SUBJECT: COMANCHE PEAK NUCLEAR POWER PLANT, UNITS 3 AND 4
DOCKET NUMBERS 52-034 AND 52-035
RESPONSES TO REQUESTS FOR ADDITIONAL INFORMATION
NO. 2864, 3295, AND 3327

Response to Request for Additional Information No. 2864 (CP RAI #32)

Response to Request for Additional Information No. 3327 (CP RAI #78)

**Figure II-1 Emergency Response Organization Interrelationships
(Alert, Site Area Emergency, General Emergency)**

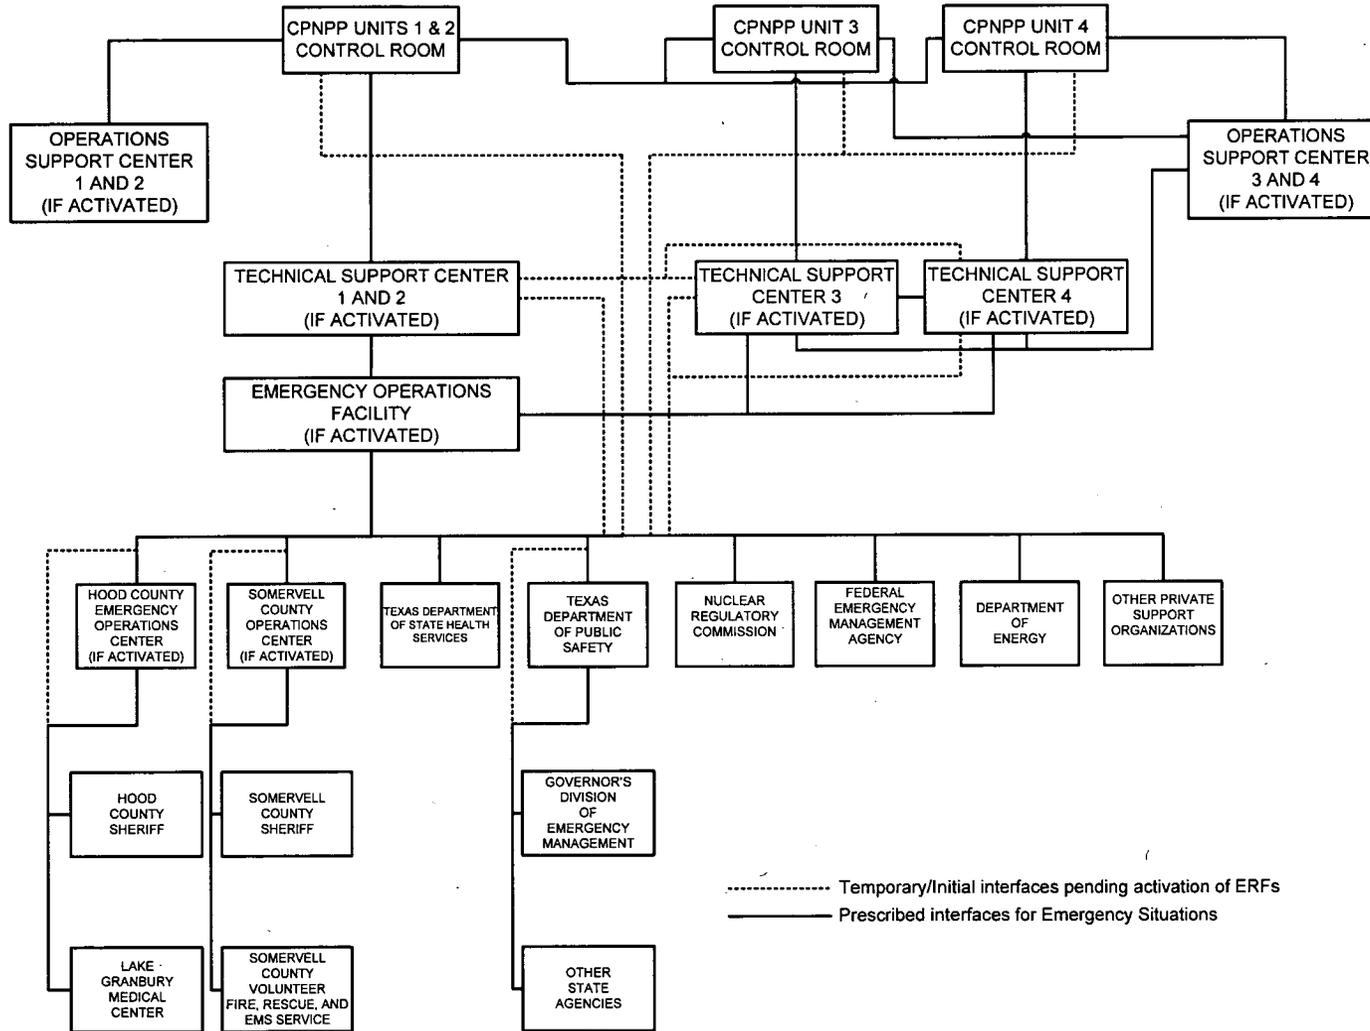
- A-1. The Texas Department of State Health Services is identified as a participating organization, but Figure II-1, "Emergency Response Organization Interrelationships," shows Texas Department of Health. The Radiation Control Program (RCP) of the Texas Department of State Health Services is identified as a participating organization, but is not shown in Figure II-1. Appendix 7, "Certification Letters and Letters of Agreement," includes letters of agreement for five organizations that are not shown in the block diagram.

- A. Clarify whether the block labeled Texas Department of Health in Figure II-1 is the same as Texas Department of State Health Services (TDSHS) in Section II.A.1.a. Revise Figure II-1 as appropriate.

- B. Discuss whether the Radiation Control Program should be shown in Figure II-1. Revise Figure II-1 as appropriate.
 - C. Discuss whether the Environmental Protection Agency (EPA) shown in Section II.A.1.b is a participating organization, and whether it should be listed in Section II.A.1.a and in Figure II-1. Revise Figure II-1 as appropriate.

- D. Discuss whether Walls Regional Hospital, Granbury/Hood County EMS, Granbury Volunteer Fire Department, Tolar Volunteer Fire Department, Indian Harbor Volunteer Fire Department, or DeCordova Bend Estates Volunteer Fire Department, which are listed in Sec.II.A.1.b, should be added to Figure II-1. Revise Figure II-1 as appropriate.

- E. Discuss whether the Cities of Stephenville, Cleburne, and Granbury, the National Weather Service, and the American Red Cross should be shown in Figure II-1. Revise Figure II-1 as appropriate.

- A-1.A Figure II-1 incorrectly referred to the Texas Department of Health. The Texas Department of State Health Services is the successor agency to the former Texas Department of Health. Figure II-1 has been revised to reflect the correct name of the State Agency (see attached marked-up pages).

- A-1.B Figure II-1 identifies the interfaces between the various Federal, State, local and private agencies in the Emergency Response Organization. The Radiological Control Program (RCP) is a part of the Texas Department of State Health Services, which has been identified in the revised Figure II-1 as discussed in the response to A-1.A, above. Therefore, no change to Figure II-1 is necessary to specifically address the RCP.

- A-1.C The Environmental Protection Agency (EPA) may provide assistance in supporting environmental monitoring teams and mobile radioanalytical laboratories, as noted in Section II.A.1.b of the Emergency Plan. However, under the National Response Framework's Nuclear/Radiological Incident Annex, the EPA is a designated cooperating agency providing assistance and support to the NRC (RIS 2005-13). As the Coordinating Agency, the NRC performs the Federal-level functions and coordinates the overall Federal response. Therefore, no change to Figure II-1 is necessary to address the EPA.

- A-1.D Figure II-1 of the Units 3 and 4 Emergency Plan was developed to be consistent with Figure 1.1 of the Units 1 and 2 Emergency Plan. The figure illustrates those organizations with primary responsibility for responding to an emergency at the CPNPP site. As described in Section II.B.6 of the Emergency Plan, Figure II-1 illustrates the interfaces among the Luminant Emergency Response Facilities (ERFs) for Units 3 and 4, Luminant Corporate Support, the State of Texas, and Somervell and Hood County government emergency response organizations.

The hospital providing care for persons injured at CPNPP, Lake Granbury Medical Center, is identified in Figure II-1. The plant is physically located in Somervell County, and Somervell County volunteer fire, rescue and EMS services are also identified in Figure II-1. Notification and communications with other hospitals and emergency services entities is initiated by

- A-1.E Stephenville and Cleburne are both located well outside the 10-mile plume exposure pathway Emergency Planning Zone (EPZ) and serve as relocation center locations. Plans and procedures for establishing and operating relocation centers by the cities of Stephenville and Cleburne were included as Supplemental Information in Part 5 of the COLA. Communication with relocation centers in those cities is conducted in accordance with Tab C to Appendix 2 and Attachment E of Annex W of the Hood and Somervell Counties' Emergency Management Plan. No change to Figure II-1 is necessary to address the cities of Stephenville and Cleburne.

The Hood County Emergency Operating Center (EOC) is identified in Figure II-1. According to Section IV.A.2 of Annex W of the Hood County Emergency Management Plan, the county and city governments will coordinate their operations from the Hood County EOC. No change to Figure II-1 is necessary to address the City of Granbury.

The National Weather Service in Ft. Worth, Texas, is identified as a back-up resource to be used if onsite meteorological data is unavailable, as discussed in Subsections II.H.6.a and II.H.8 of the Comanche Peak Units 3 and 4 Emergency Plan. It is not a primary emergency response agency, therefore does not need to be included in Figure II-1.

Figure II-2

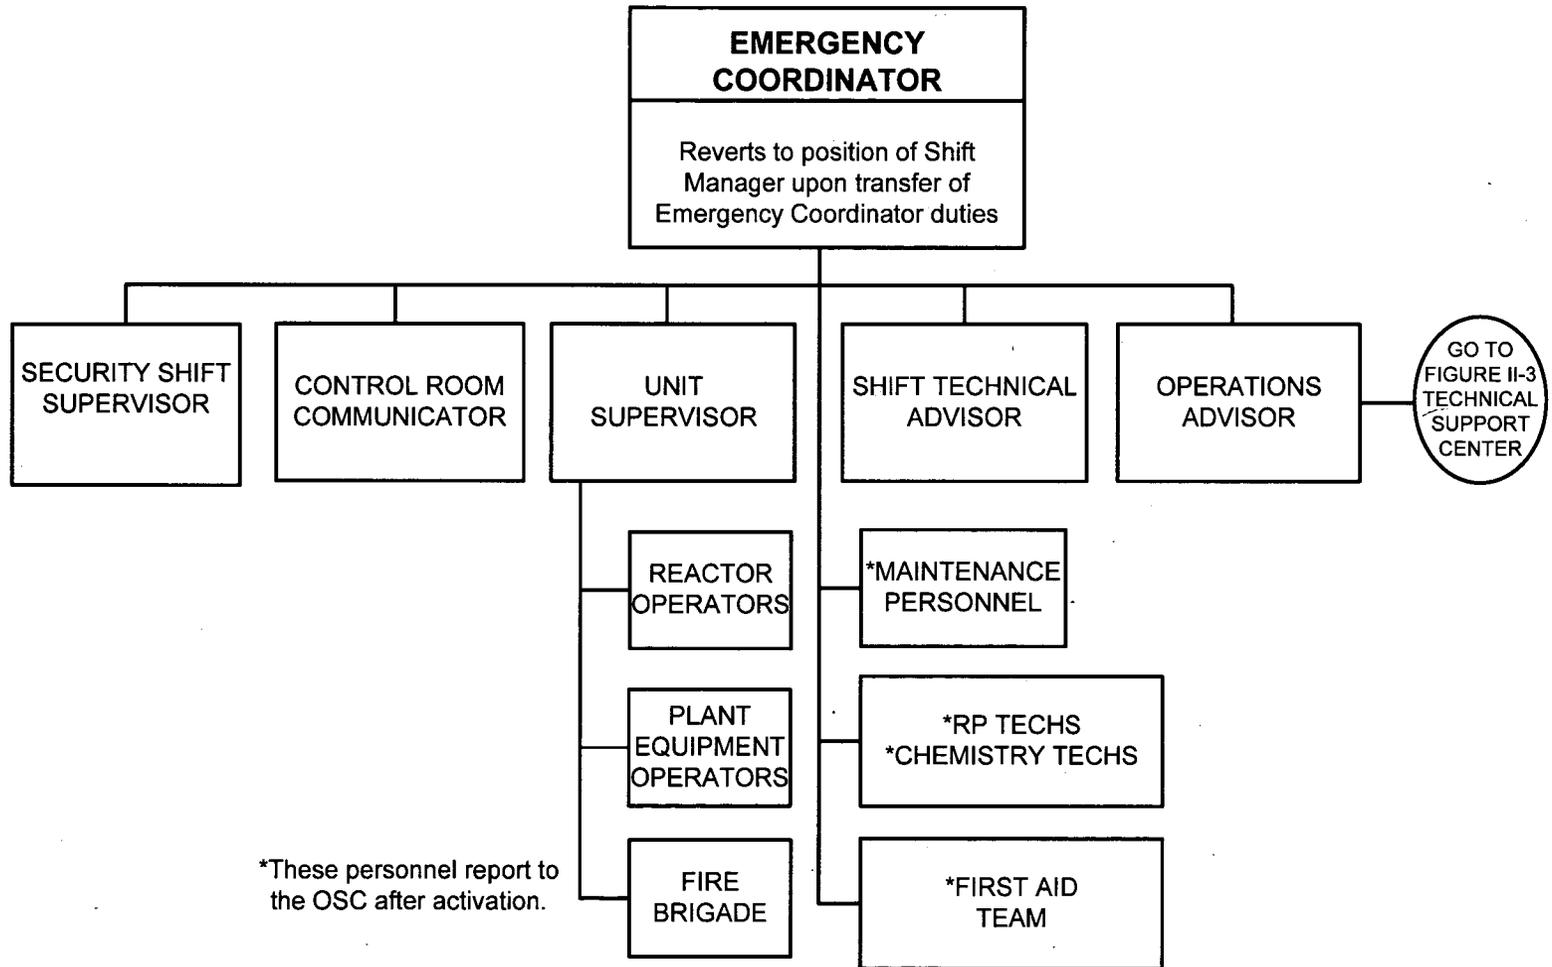
- A. The Security Shift Supervisor described in Section II.B.1 is not shown in Figure II-2. Discuss why the security function is not included in Figure II-2, and revise Figure II-2 as appropriate.

- B. The Emergency Repair & Damage Control Emergency Team described in Section II.B.1 is not shown in Figure II-2. Describe whether the function of emergency repair and damage

control is represented by Maintenance Personnel in Figure II-2. Revise Figure II-2 as appropriate.

B-3.A. Section II.B.1 of the Emergency Plan describes the principal responsibilities that are assigned to the Operations Shift until relieved by members of the ERO. The Security Shift Supervisor has been added to Figure II-2. In addition, Section II.B.1 has been revised by re-ordering the first two paragraphs, which should clarify that Figure II-2 is for the initial phase of an emergency.

B-3.B Section II.B.1 of the Emergency Plan describes the principal responsibilities that are assigned to the Operations Shift until relieved by members of the ERO. The Maintenance Personnel shown in Figure II-2 perform the Emergency Repair and Damage Control function initially, until such time as the Operations Support Center (OSC) is manned. Section II.B.5 includes a description of the Emergency Repair & Damage Control Emergency Team Coordinator as follows:

There is no need to revise Figure II-2. However, as discussed in response to part B-3.A above, Section II.B.1 has been revised to improve clarity.

Figure II-4 Emergency Response Organization – Operations Support Center

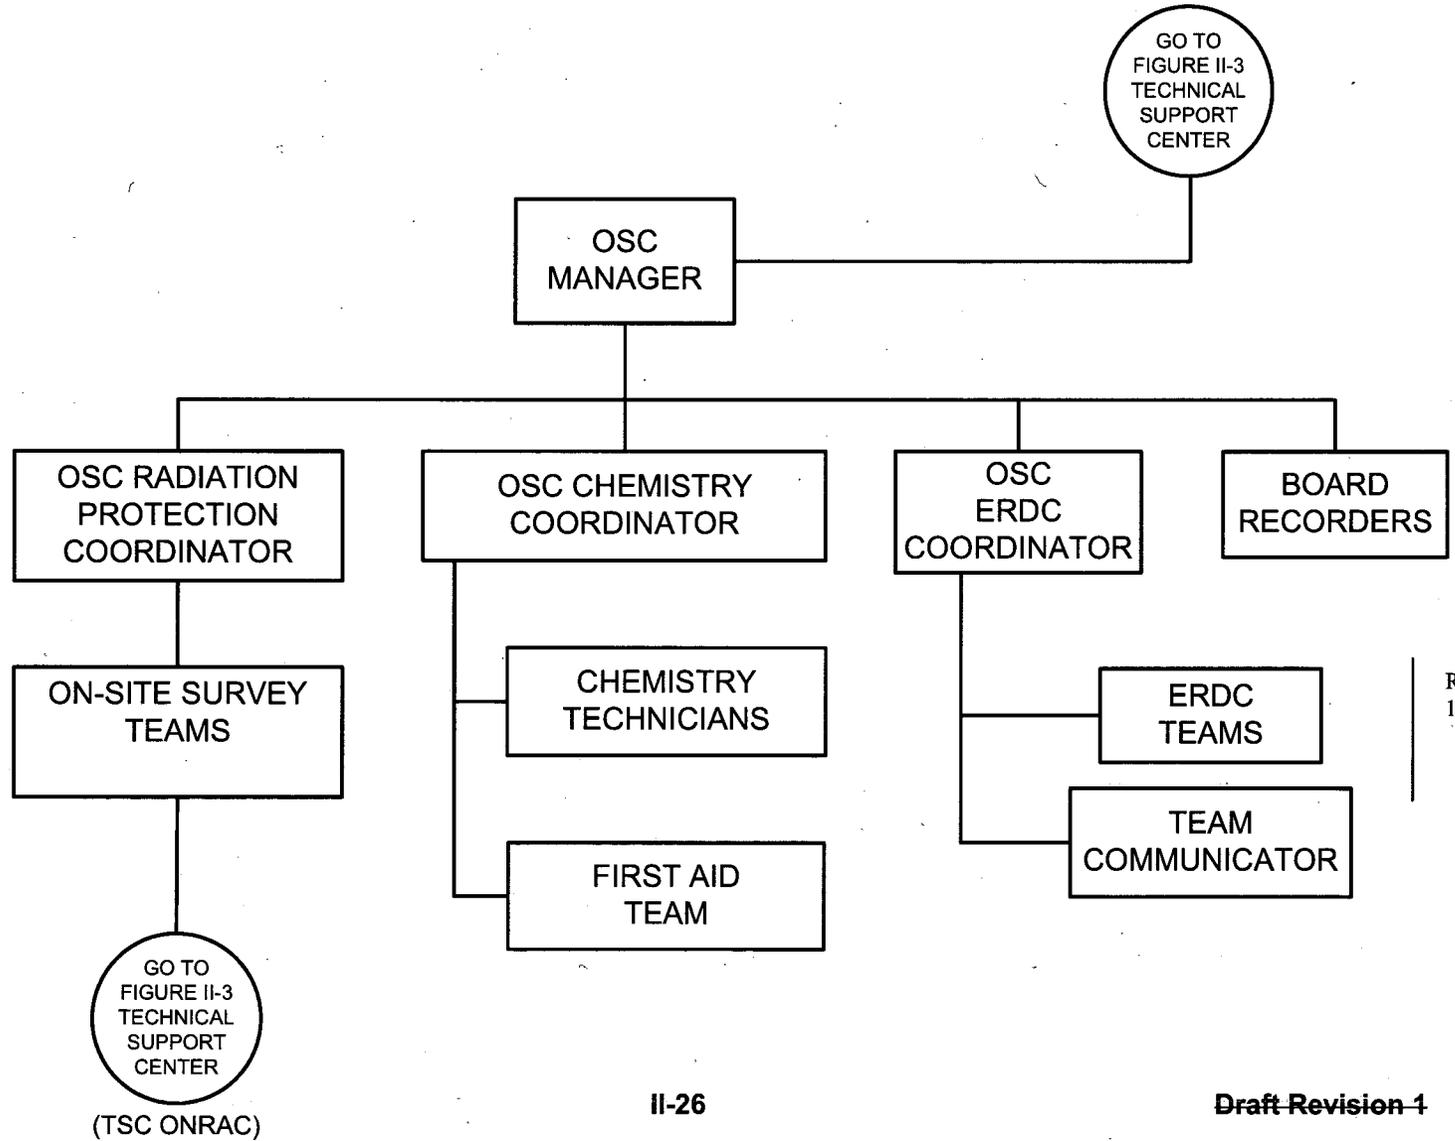
- E. Section II.B.5, "Plant Emergency Response Positions," includes a description of On-Site Survey Teams dispatched from the OSC; however, Figure II-4, "Emergency Response Organization – Operations Support Center," does not include an entry for On-Site Survey Teams. Clarify if the Radiation Protection Technicians shown in Figure II-4 are equivalent to the On-Site Survey Teams described in Section II.B.5.

- B-3.E. The Radiation Protection Technicians shown in Figure II-4 are equivalent to the On-Site Survey Teams described in Section II.B.5. It is important to note that the second member of a two person team need not be an RPT. Figure II-4 has been revised to include "On-site Survey Teams."
